Subject: Duke Energy Carolinas, LLC
Oconee Nuclear Station
Renewed Facility Operating Licenses Numbers DPR-38, DPR-47, and DPR-55;
Docket Numbers 50-269, 50-270, and 50-287
Responses to Request for Additional Information for the License Amendment
Request to Revise Portions of the Updated Final Safety Analysis Report Related to
the Tornado Licensing Basis; License Amendment Request: 2006-009

On July 6, 2009, Duke received a Request for Additional Information (RAI) in regards to the LAR [Ref. 2]. This submittal contains Duke's responses to that RAI. Within this document, the attachment contains Duke's responses to the RAI and supporting documentation is provided in the enclosure.

Duke Responses to RAI

ONE-LINE DIAGRAM
MAIN PSW SWITCHGEAR
13.8/4KV SYSTEM

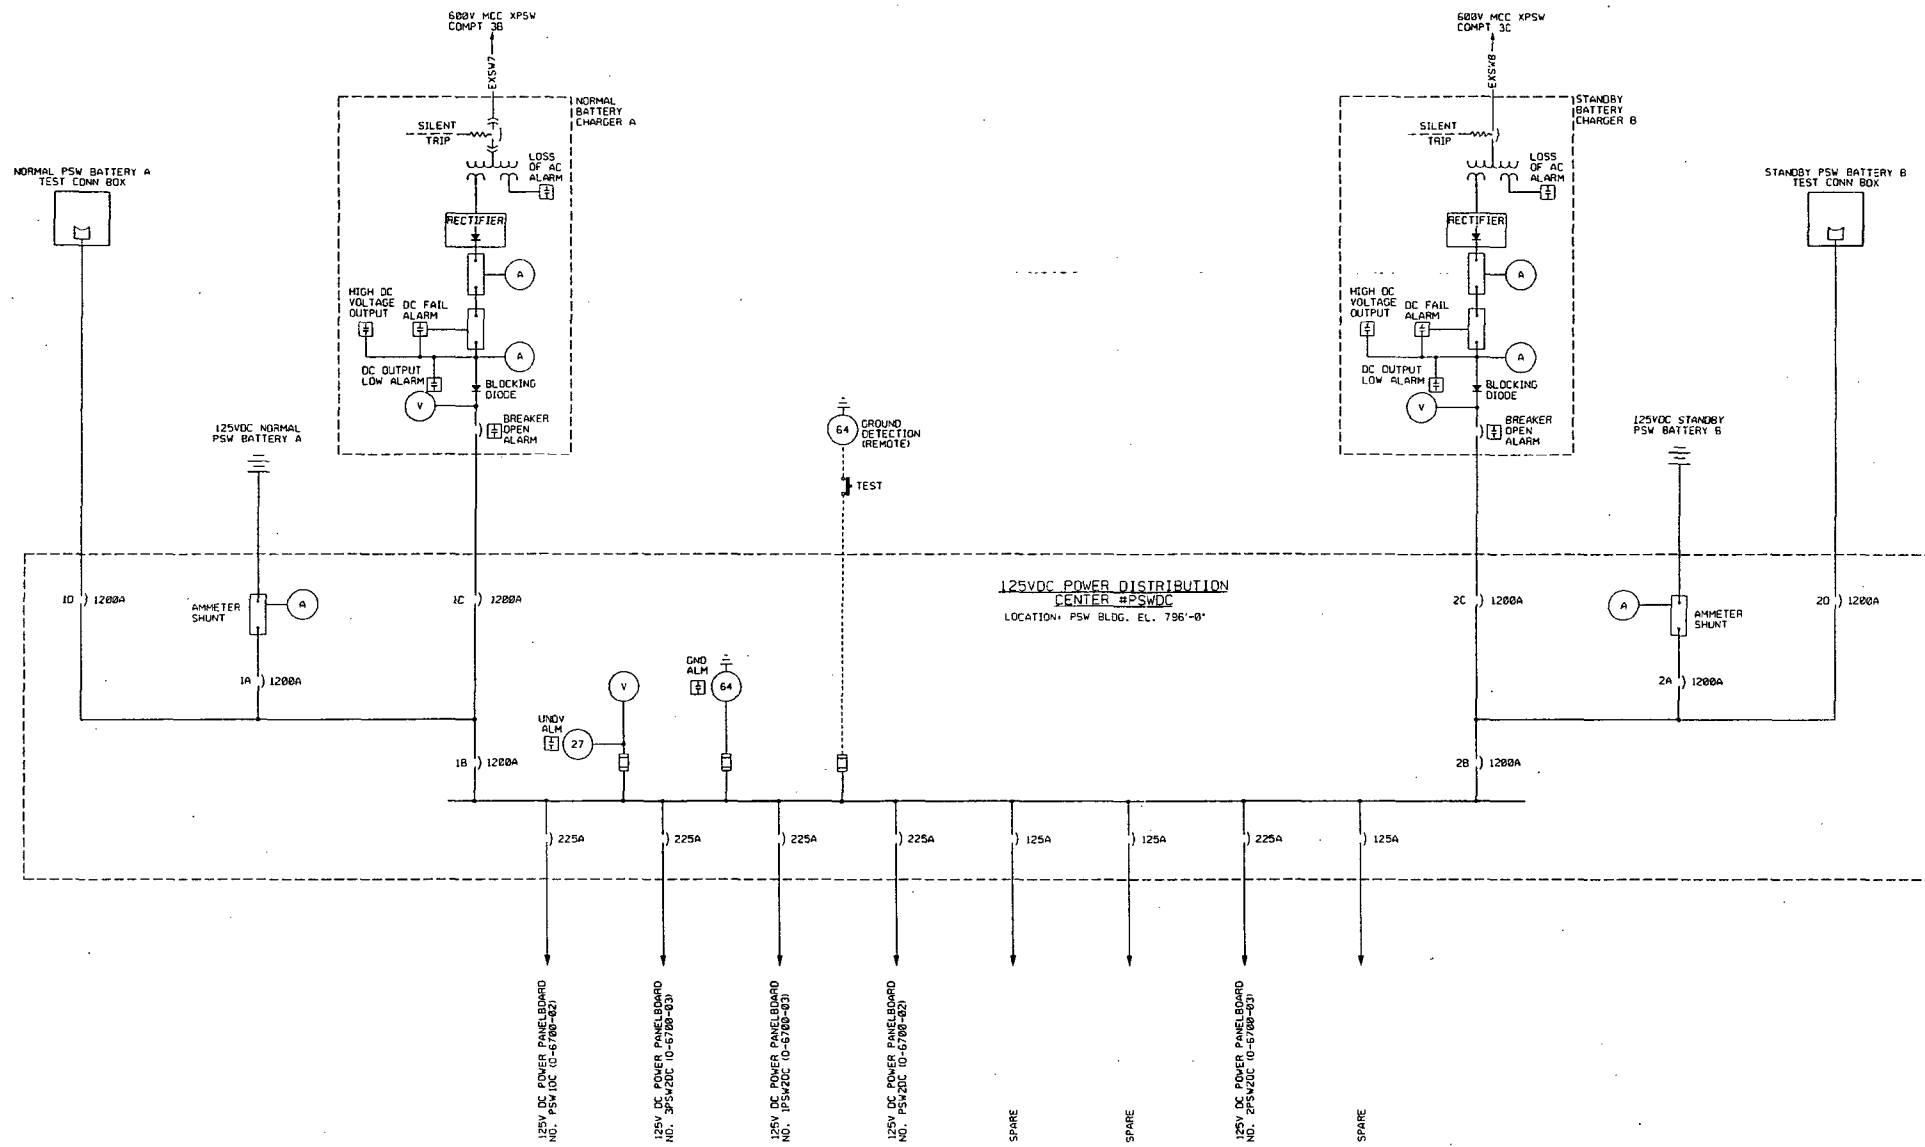
Provide the following information for the new protected service water (PSW) transformer, switchgear, load center and the circuit breakers: 1) equipment design ratings, 2) a summary of the analyses performed to show the loading, short circuit values and the interrupting ratings, voltage drop, and protection and coordination, 3) the existing station auxiliary service water (ASW) switchgear ratings, and 4) the periodic inspection and testing requirements for electrical equipment. Provide applicable schematic and single line diagrams.

In Enclosure 2, Section 3.3.4 of the LAR, the licensee states that the Keowee Hydroelectric Units (KHUs) will provide power supply to the PSW switchgear through underground cables. Provide analyses to show the kilo volt ampere (kVA) loading, new circuit breaker rating, short circuit values, and voltage drop. In addition, provide information on the electrical protection and coordination, and the periodic inspection and testing requirements. Further, explain how the redundancy and independence of the Class 1E power system is maintained as a result of the proposed modification. Provide applicable schematic and single line diagrams.

1. The 13.8kV/4.16kV switchgear is a double ended unit substation. Each unit substation consists of normal and alternate 13.8kV power source breakers, a 13.8kV/4.16kV step down transformer, and a 4.16kV main breaker connected to its respective 4.16kV switchgear buss. The two 4.16kV switchgear busses may be connected through a 4.16kV tie breaker. Switching power source breakers is performed by manual dead bus transfer. The design ratings for the PSW electrical equipment are as follows:

- O-6700 – One-Line Diagram Main PSW Switchgear
- O-6707 – One-Line Diagram 600V PSW Bldg, MCC XPSW Loadcenter OCPSW1

4. The PSW electrical system has a normal (13.8kV Fant Line) and alternate (13.8kV Keowee Hydro Unit) 13.8kV power source breaker to each PSW Unit Substation. The redundancy of the PSW power system is provided through these two power sources. The Keowee Hydro Unit 13.8kV power source cables to the PSW electrical system will be routed in a combination of precast concrete trench boxes, duct banks, and manholes. The power feeds from Keowee Hydro Unit to both Oconee Nuclear Station and the PSW electrical equipment are isolated by separate breakers and disconnect switches. Independence is maintained as required by Duke Design Criteria DC 3.13.

- O-6700 – One-Line Diagram Main PSW Switchgear
- K-700 – Keowee Hydro Station – One-Line Diagram

**CABLE ROUTING DIAGRAM (SCHEMATIC)
ELEVATION LOOKING EAST**

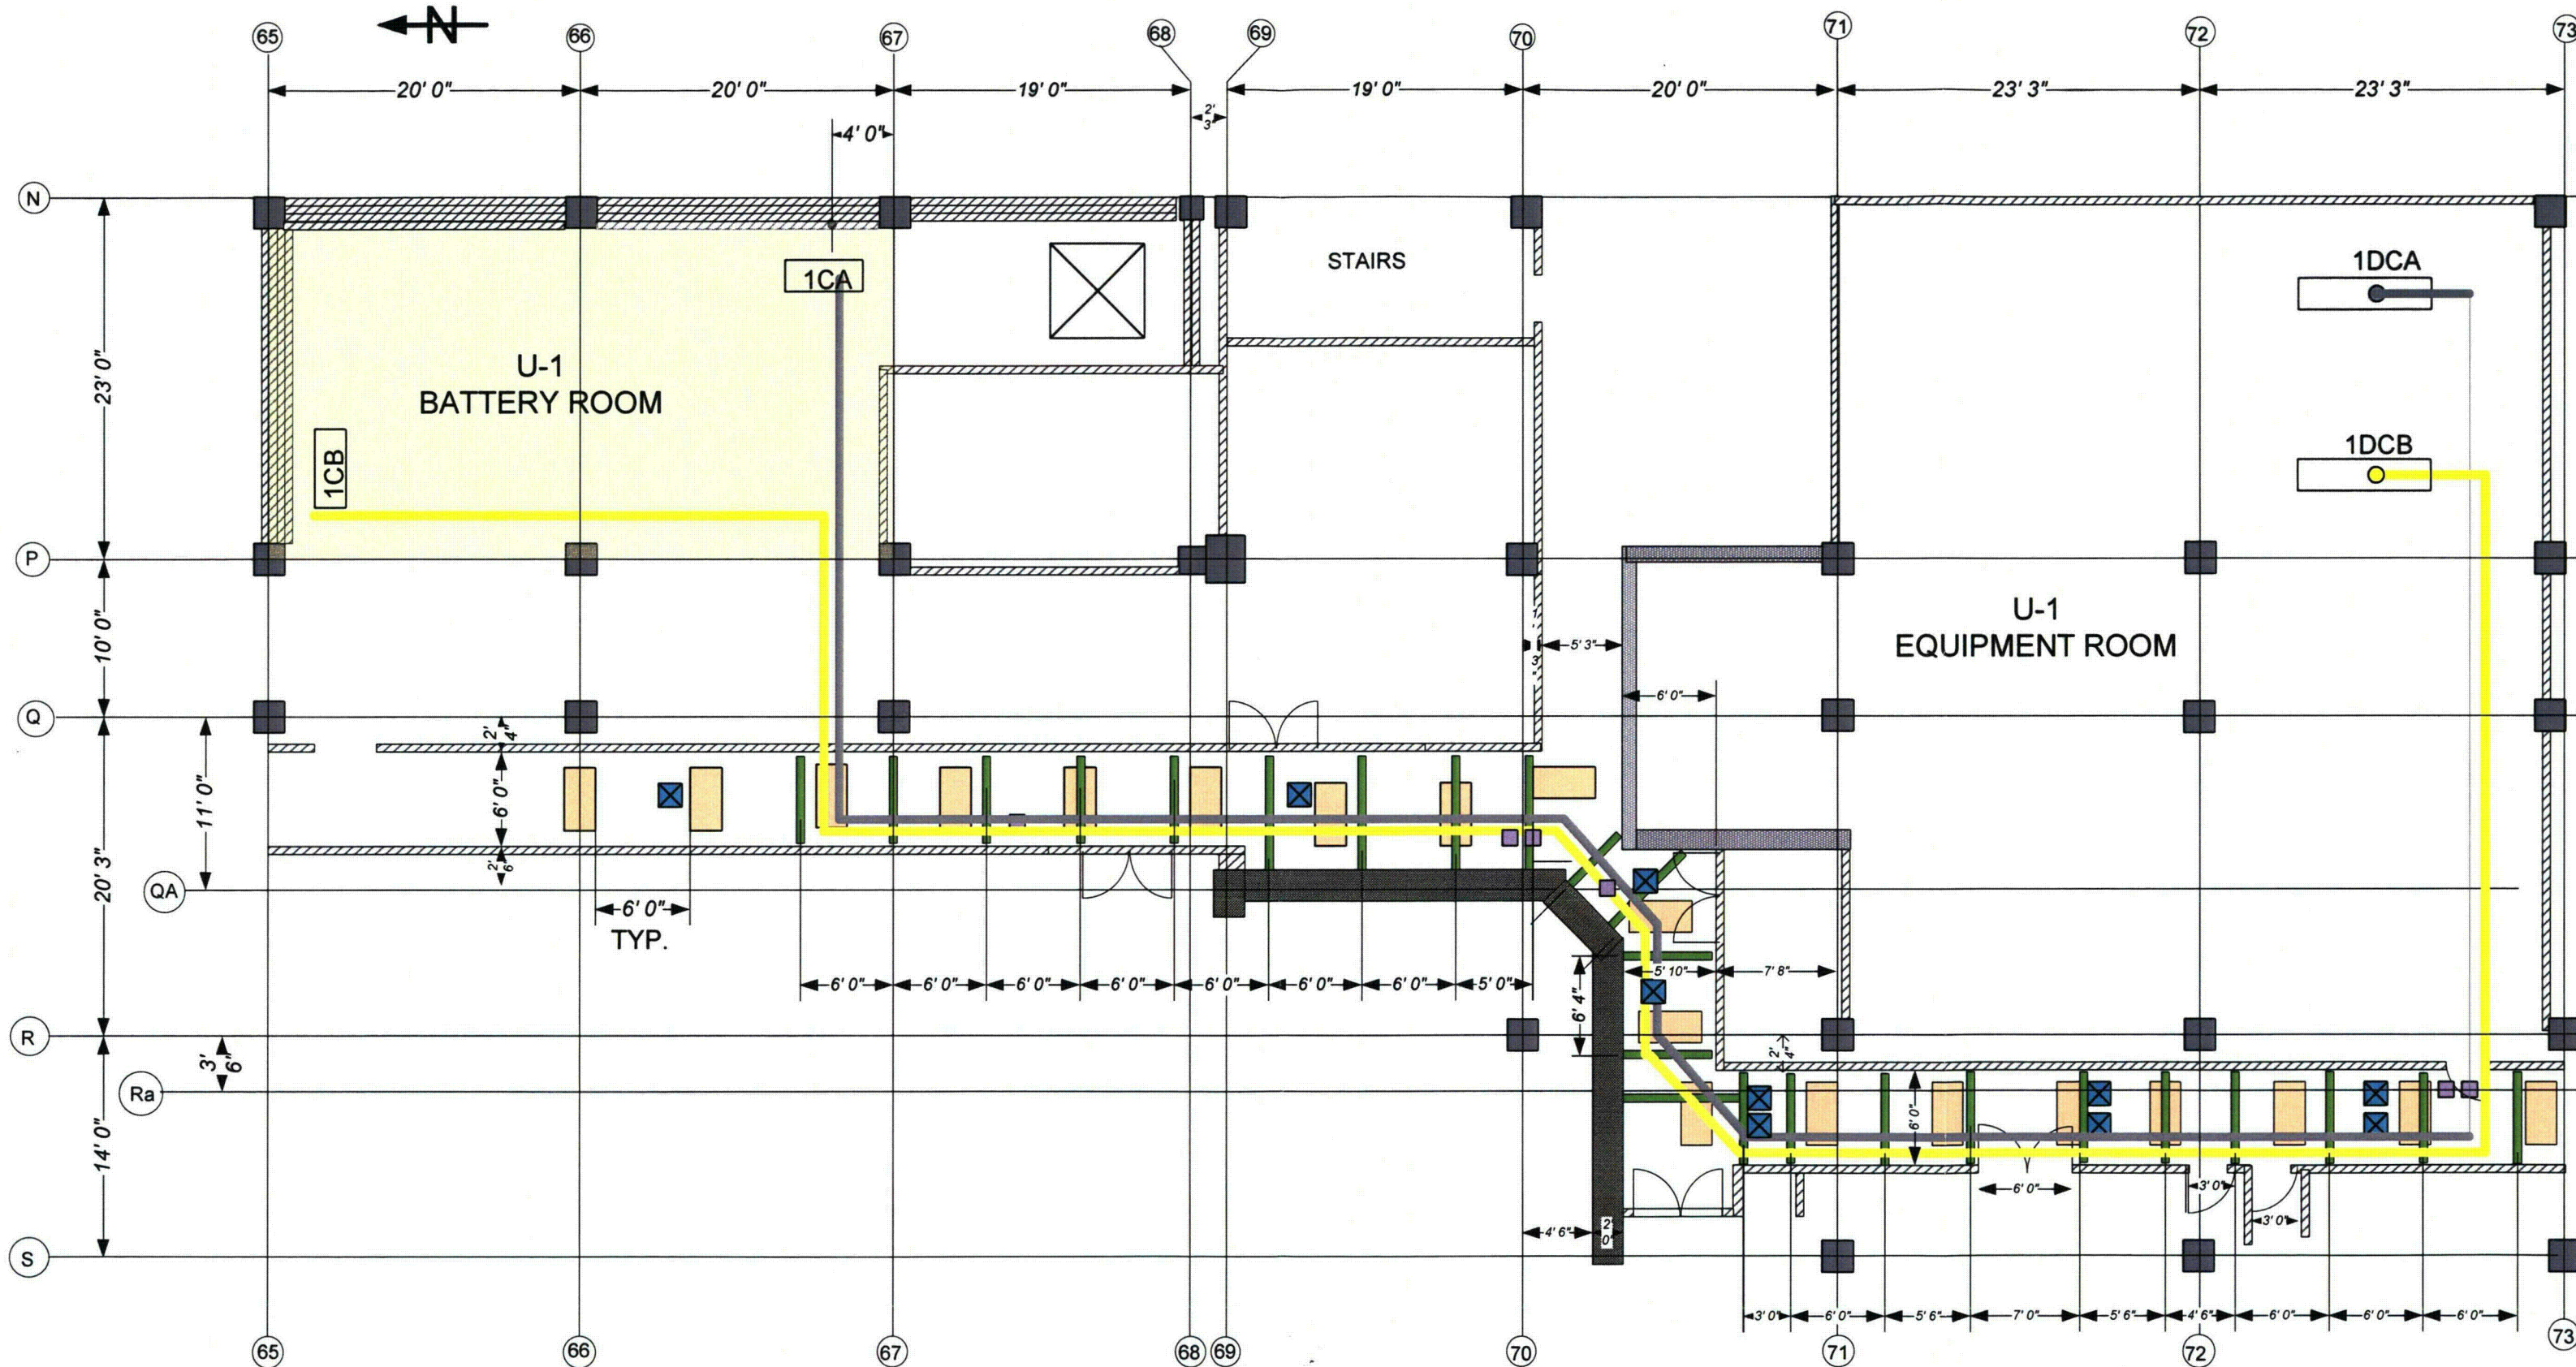
Describe in detail how the 125 VDC vital I&C primary and backup power cables and the KHU emergency start circuitry will be rerouted from the turbine building (TB) to the AB.

This design change provides new routing for the Keowee Hydro Units (KHU) emergency start cables. The existing underground spare cables between KHU and the Oconee Station will be used. For tie-in to control and logic, these underground cables will be extended with new cables between KHU termination cabinets to KHU control panels and Oconee termination cabinets to control panels in the Auxiliary Building. New emergency start cables will be installed from the 230 kV switchyard relay house via a new protected underground duct bank to the PSW switchgear building and, underground via protected duct bank, to the Auxiliary Building control panels.
